Subject: Crystal River Unit 3
Docket No. 50-302
Operating License No. DPR-72
Identification and Resolution of Long-Term Generic Issues
Related to the Commission of May 1979

With reference to ATTACHMENT A TO ENCLOSURE 1, LISTING OF OUTSTANDING ITEMS RELATED TO B&W SMALL BREAK ANALYSIS, of your subject letter dated August 21, 1979, attached are:

RESPONSE TO QUESTION 1B OF ATTACHMENT A TO D. F. ROSS
(NRC) LETTER DATED 8/21/79

FIGURE 2
SYSTEM PRESSURE

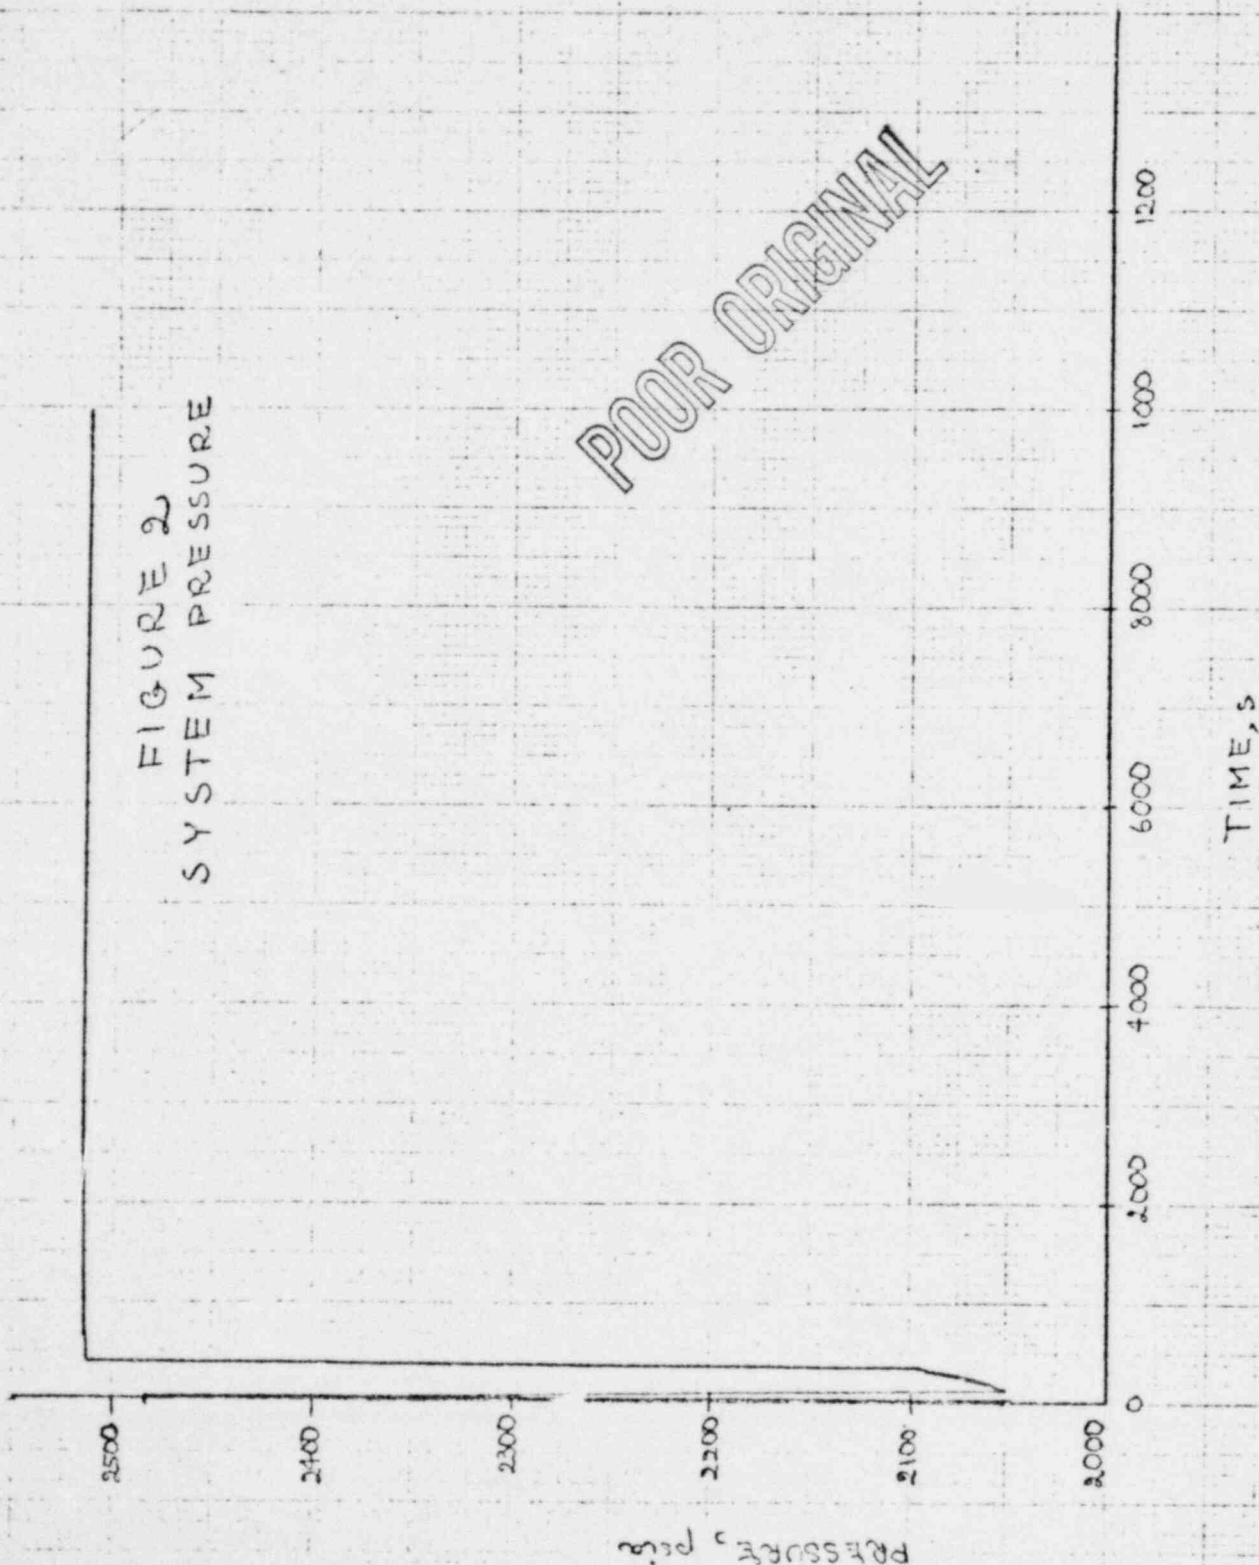
Figure 2 shows the core pressure transient. Following the simultaneous loss of main feedwater and offsite power, the fluid in the RCS expands due to decreasing heat transfer via the steam generator, and the RCS pressure increases. At 8 seconds, the high pressure trip setpoint (2300 psig) is reached, thus causing the reactor to scram. Pressure then starts to decrease due to contraction of the fluid in the RCS caused by the decrease in core power. At 100 seconds, the steam generator inventory has been boiled-off, which results in a loss of heat sink and a heatup of the RCS fluid, and repressurization of the system. At 350 seconds, the pressurizer becomes "solid," and the system pressure rapidly increases to the code safety valve set pressure of 2500 psig. The system pressure remains at this value for the remainder of the transient with the safety valves acting as a path to the ultimate heat sink of the RCS for this accident, i.e., the containment.

FIGURE 3

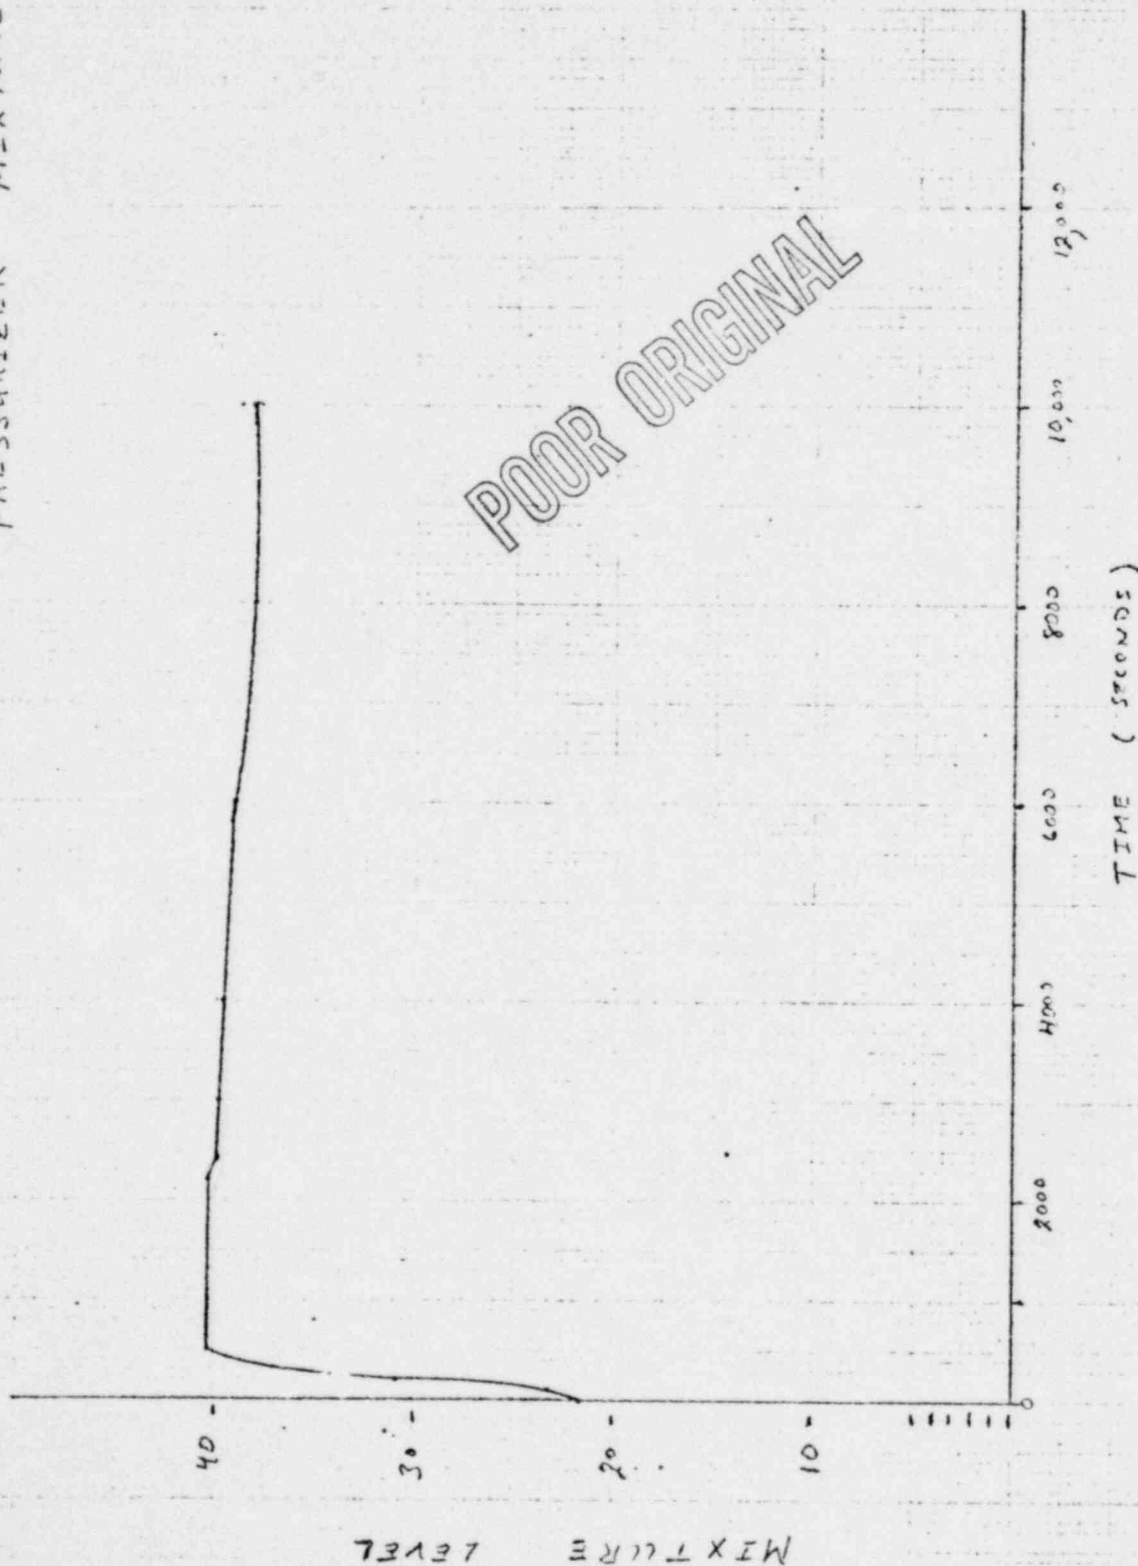
Figure 3 shows the pressurizer mixture level response for this accident. The initial pressurizer response follows the same behavior as the system pressure transient. Due to the loss of heat sink at 100 seconds, the pressurizer starts to refill and becomes solid at 350 seconds. At 2180 seconds, the liquid level in the primary system falls below the surge line entrance and steam passes into the pressurizer. Shortly thereafter, the pressurizer mixture level drops slightly and steam exits through the code safety valves. The pressurizer remains in this condition for the remainder of the transient.

FIGURE 5
SYSTEM VOLUME EXCLUDING
PRESSURE ZONE

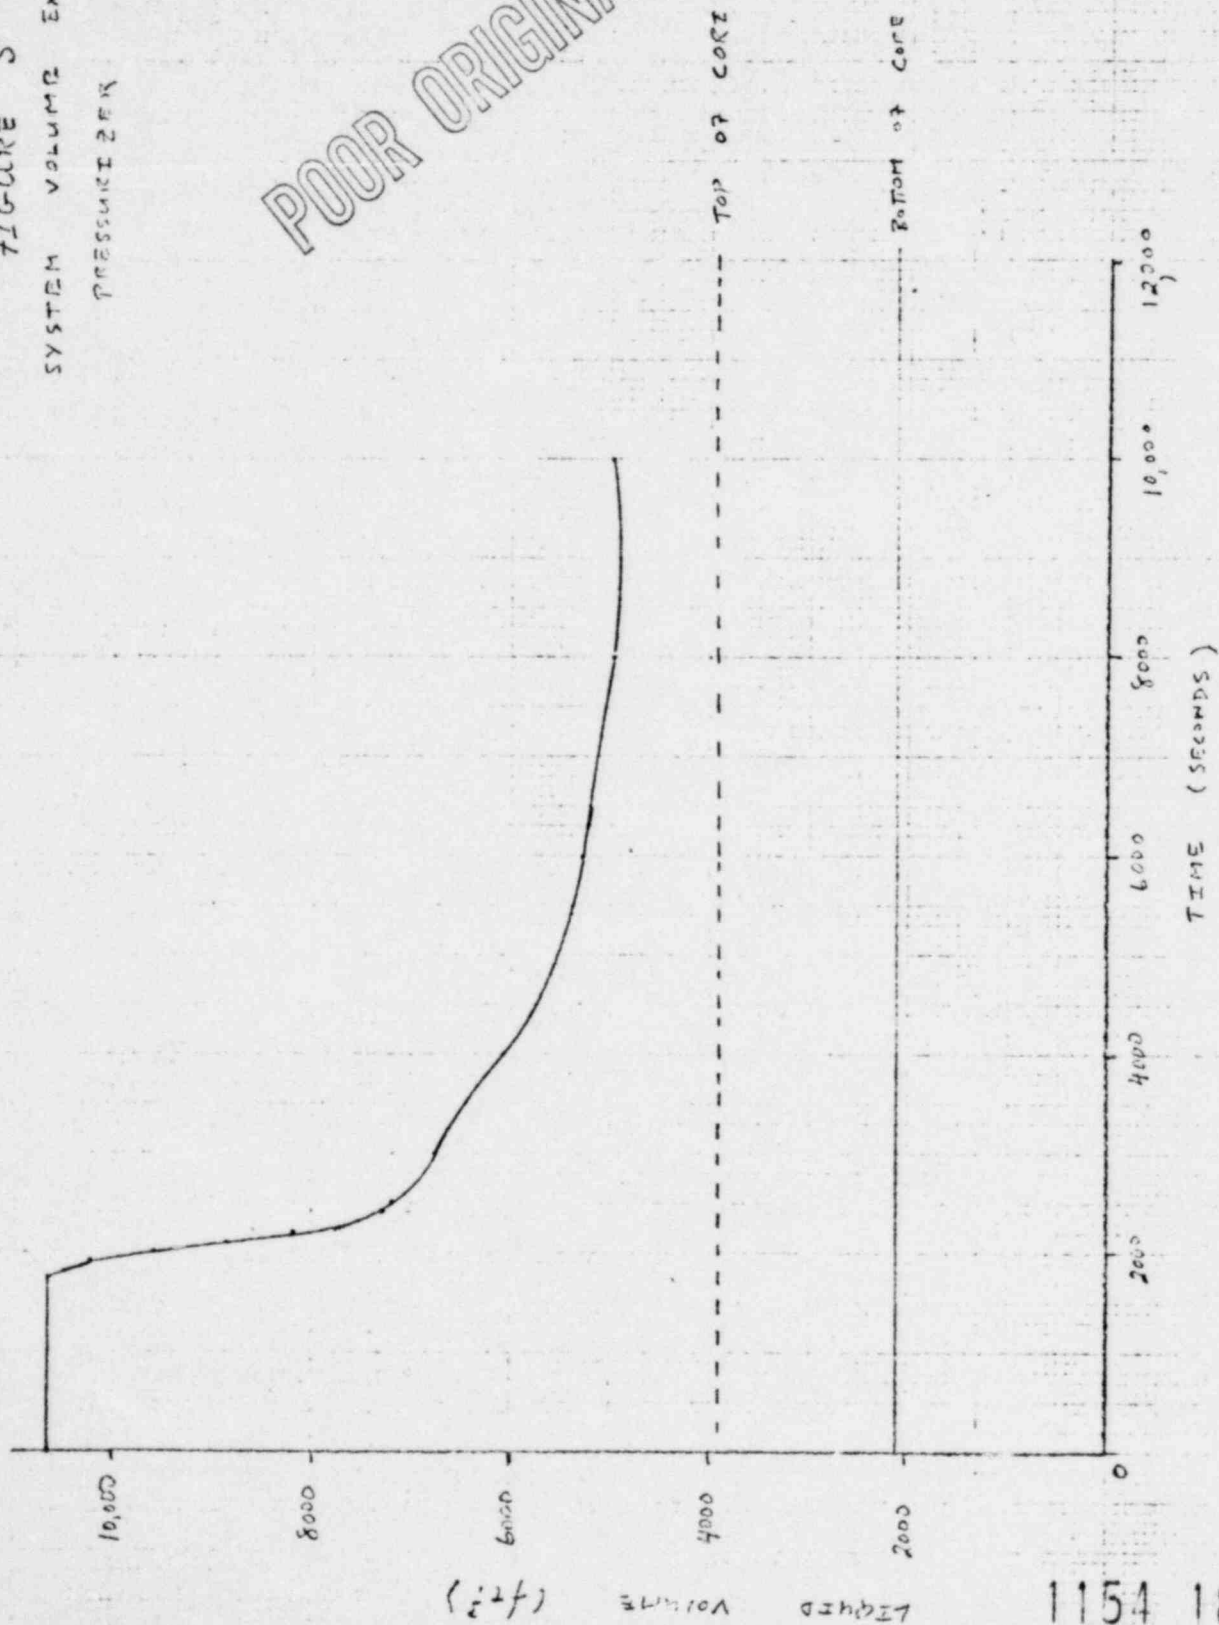
The RCS liquid inventory, with the exclusion of the pressurizer, during this transient, is given in Figure 5. Makeup to the RCS was initiated at 1200 seconds via operator action to start one HPI train. The RCS reached saturated conditions at 1725 seconds, and rapidly starts decreasing in inventory. With the liquid level in the primary system falling below the pressurizer surge-line nozzle at 2180 seconds, the loss rate in system inventory slows. At 8900 seconds, the HPI flow exceeds the core boil-off and the system starts to refill. At no time does the core uncover. Thus, the cladding temperatures will be maintained within a few degrees of the saturated fluid temperature and no cladding ruptures nor metal-water reaction will occur.

FIGURE 3 REACTOR COOLANT PRESSURE

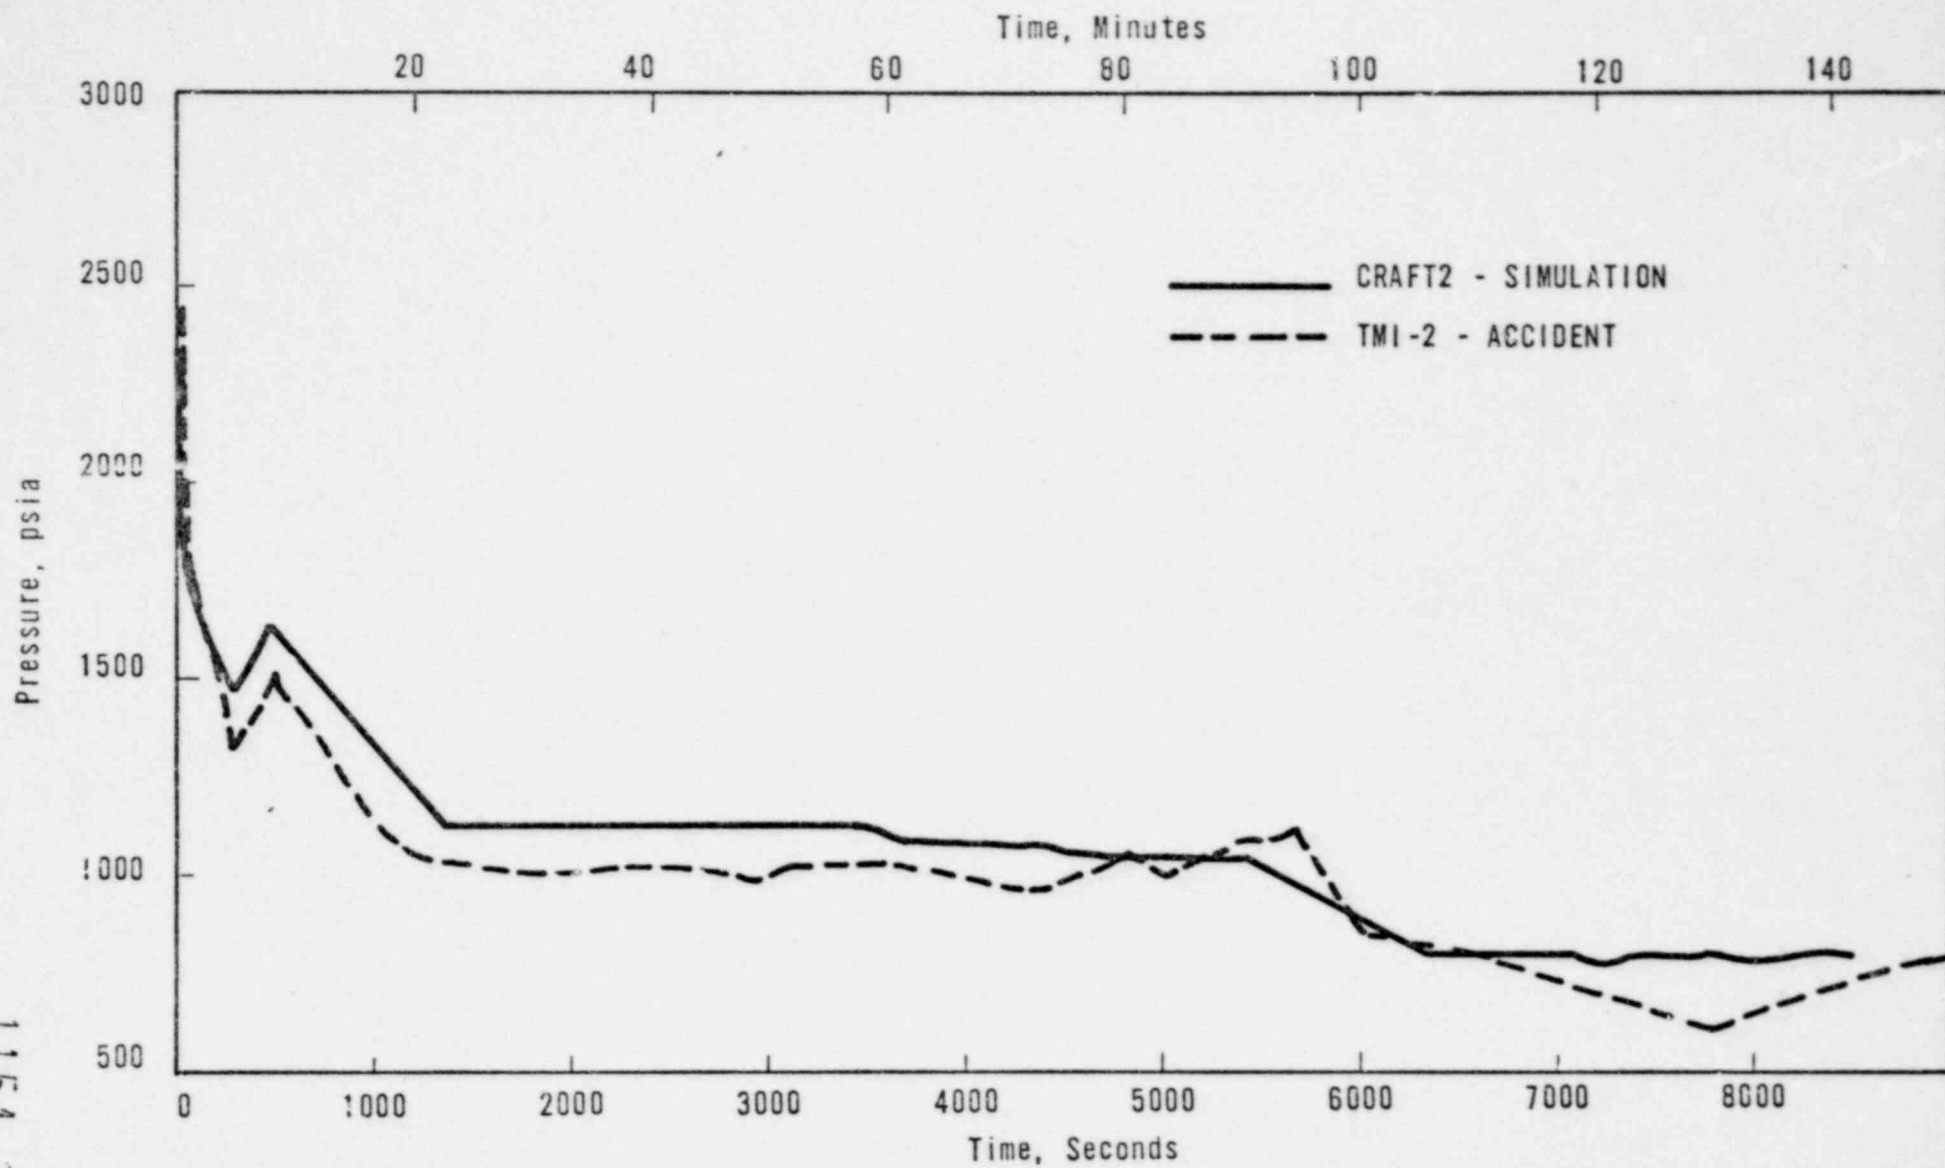
Approximately 5 minutes into the transient, the fluid in the hot leg flashed due to the depressurization of the RCS and the system pressure increased. As indicated on Figure 3, the CRAFT2 code properly predicts the system repressurization time, but overpredicts the actual pressure. The overprediction of system pressure is probably caused by the assumed net makeup to the RCS during this time period. Although the HPI was throttled to a net makeup of 34 gpm during this time interval in the simulation, between 4:58 and 6:58, the NSAC scenario of events indicate that the letdown flow was in excess of 160 gpm. Thus, it is quite probable that there was a decrease in inventory in the RCS due to the high letdown over this time period.

At 8 minutes and 18 seconds, auxiliary feedwater flow was readmitted to the SG and primary system pressure decreased (Figure 3) to approximately 1100 psig and was maintained at that value up to approximately one hour and 20 minutes.

As shown by Figure 3, the CRAFT2 prediction is greater over this period by about 100 psi. The coolant pressure was measured in the hot leg during the accident; the predicted system pressure shown is the core pressure. The actual predicted hot leg pressure is about 60 psi lower than the predicted core pressure. Also, the pressure in the secondary side was held in the CRAFT2

FIGURE 4 PRESSURIZER LEVEL

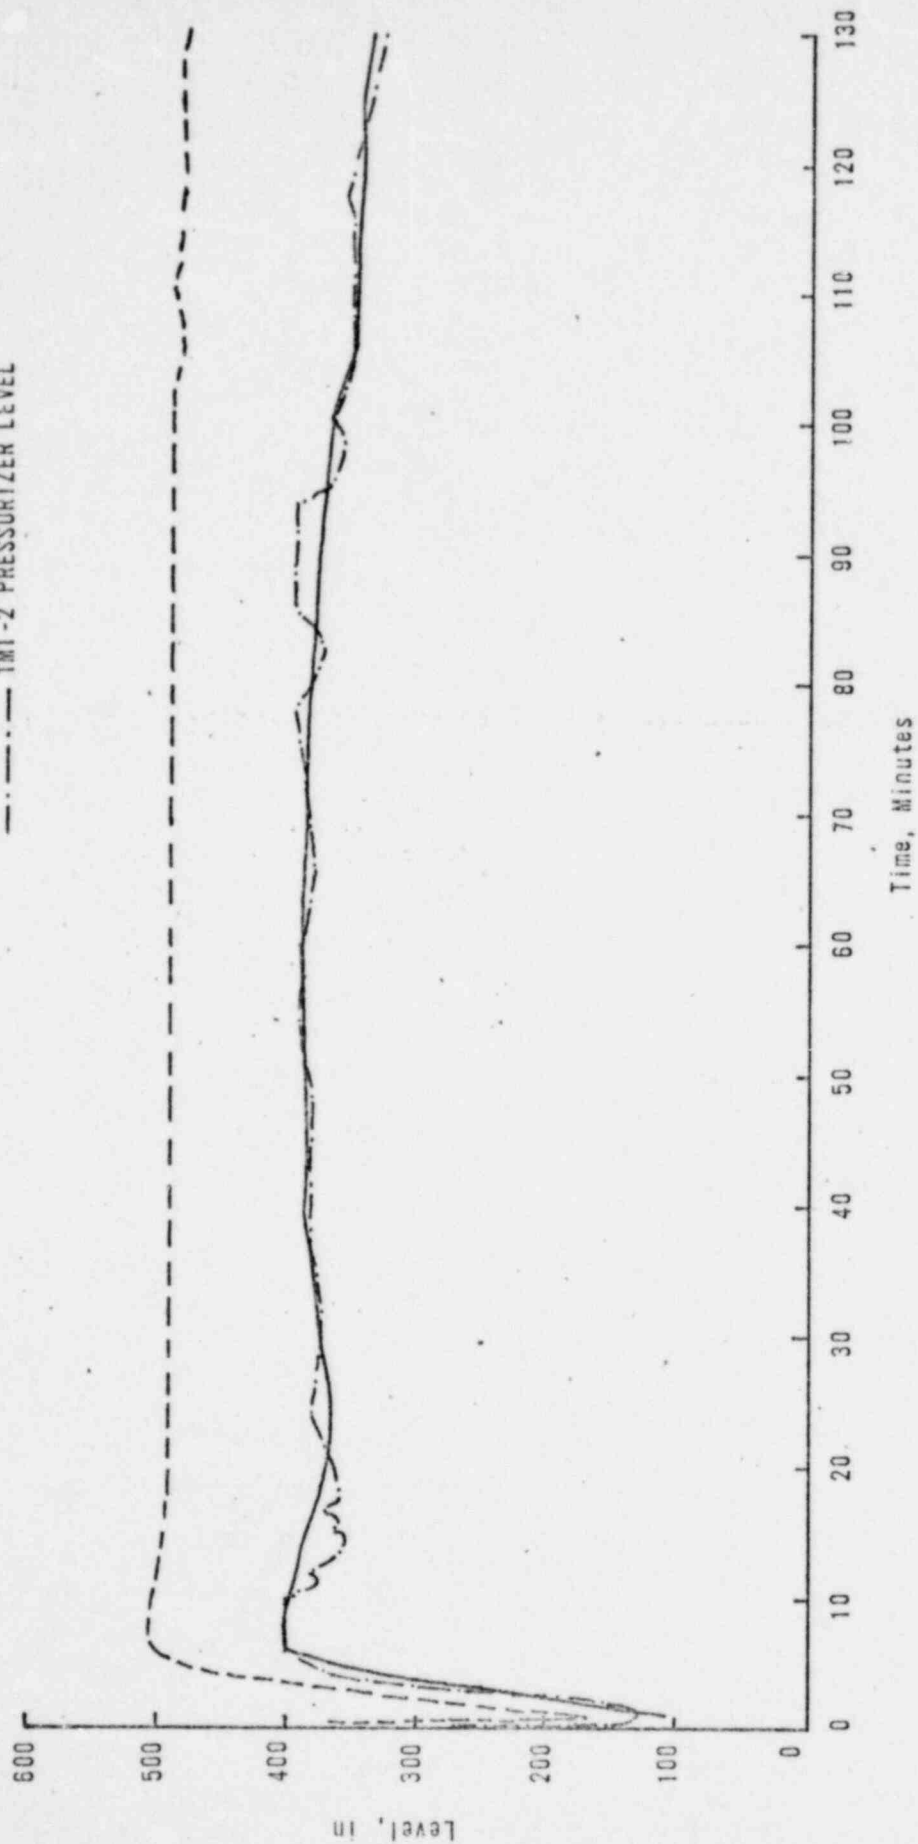
A comparison of the CRAFT2 predicted pressurizer level to the TMI-2 data is provided in Figure 4. As shown, there are two pressurizer level predictions given in the figure. The first, entitled mixture level - CRAFT, is the calculated mixture level within the pressurizer. The second, entitled instrumentation reading - CRAFT, is the calculated liquid level that would be "seen" within the pressurizer level taps and is directly comparable to the TMI-2 data.

The initial pressurizer response and comparison to the loss of main feedwater event (first 4 minutes of the transient) is not easily discernable in Figure 4. It was, however, discussed in the May 7, 1979, report. During this phase of the accident, the pressurizer level responded in a similar manner as the system pressure. Also, the comparison of the predicted to the actual response of the pressurizer level is similar. That is, the rise in pressurizer level during the first 10 seconds is overpredicted and the pressurizer level after reactor trip is underpredicted. The reasons for this are the same as those discussed previously in section 3.1.

The significant aspect of this comparison is the predicted mixture level response to the predicted instrument reading response during the transient.* As shown by Figure 4, the predicted instrument response and the measured response are in good agreement throughout the simulation. However, as shown by the figure, although the instrument reading is on scale for portions of the first 101 minutes of the transient, the actual predicted mixture level after 6 minutes is at the top of the pressurizer. Thus, a two-phase mixture exited through the valve during this entire period. After 101 minutes, only steam was entering the pressurizer through the surge line (note that the RC pumps have been tripped), and the pressurizer mixture had reached a sufficient void fraction to allow for phase separation at the top of the mixture and only steam started to flow out.
